Response to planning consultation 23/4152M re The Dam Embankment of Poynton Pool, Poynton Park, London Road North, Poynton.

1. Background

This submission deals with the reasons for deferral at the SPB and comments on the Planning Officer's report to the SPB which was not available at the time of Poynton Town Council's initial consultation response.

Figure 12 Indicative hydrological catchment of Poynton Brook

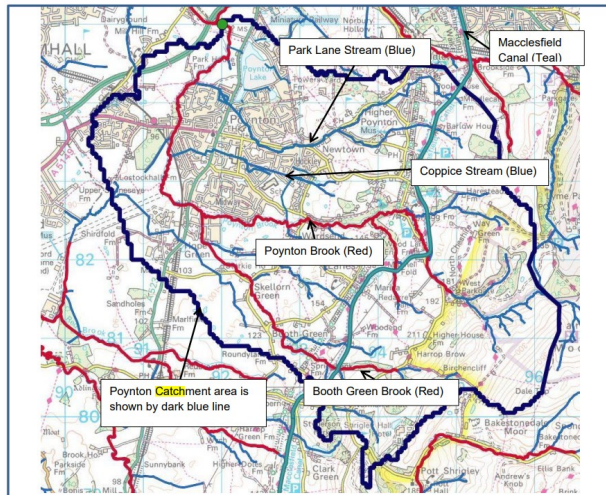
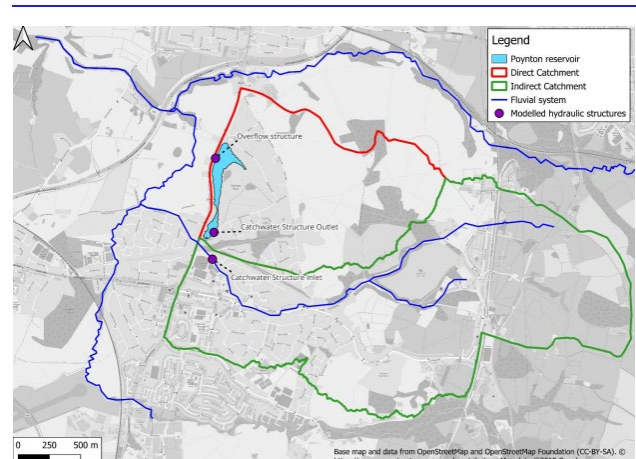
The applicant has not provided a substantive response only stating that previous flooding events were in a different catchment. They were not. The section 19 report¹ on Flooding in Poynton in 2019 identifies the Poynton Brook catchment (Figure 12) which clearly includes the pool and its entire direct and indirect catchment (see comparison with catchment taken

from the October 2025 Hydrology and Modelling Report). No explanation has been provided as to the discrepancies in the various reports and why the model appears to be so at odds with the observed reality (see Town Council's first response to the planning application for further details on historical flooding).
